DRAFT

**Specific Site Assessment for
Coal Combustion Waste
Impoundments at Duke
Energy Indiana (DEI)
Cayuga Generating Station**

Cayuga, Indiana

September 2010
Project 092882

Figure 3

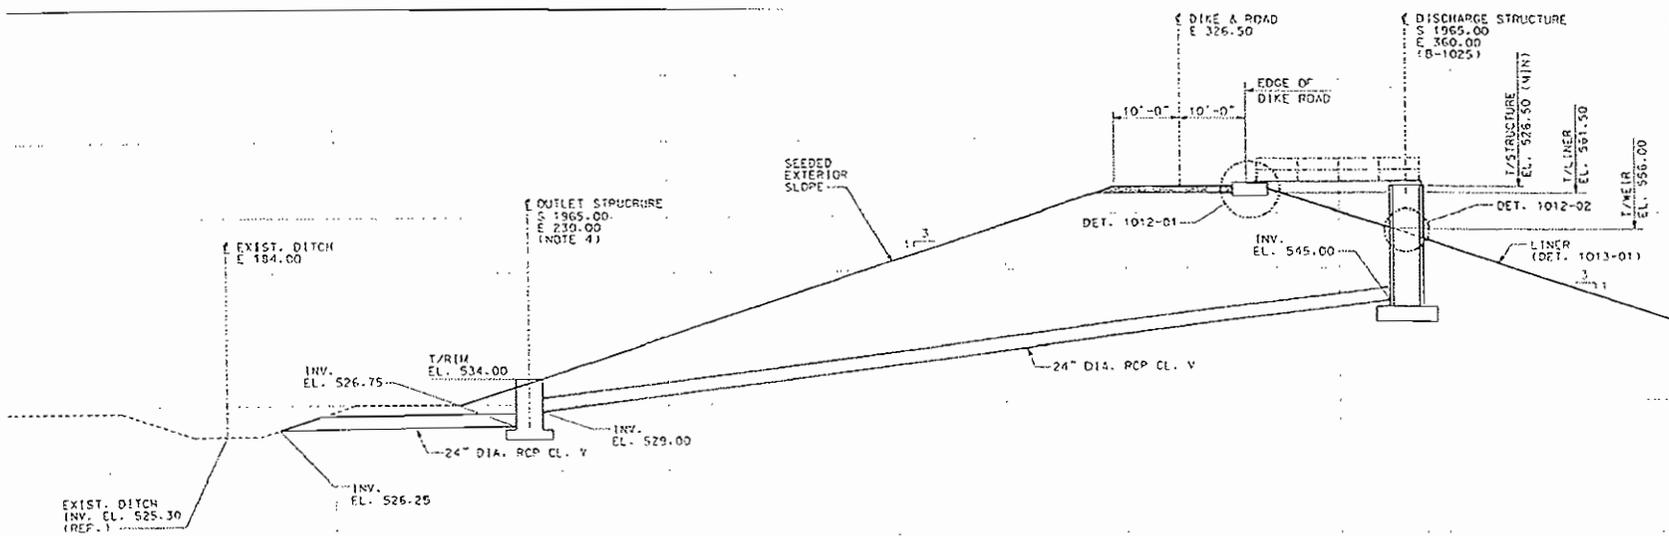
The perimeter dike and Secondary Ash Settling Basin east dike were constructed of homogeneous fill material. The 1998 divider dike for the Primary Ash Settling Basin was constructed of homogenous fill material. However, the divider dike may have been founded on CCW material since the dike was constructed after ash had been previously sluiced into the Original Ash Pond. The Lined Ash Disposal Pond – Cell #1 dikes were constructed of, and founded on, co-mingled bottom and fly ash that had been deposited into the Original Ash Pond. Typical geometries of the dikes are presented in Table 2.1 and Figure 3.
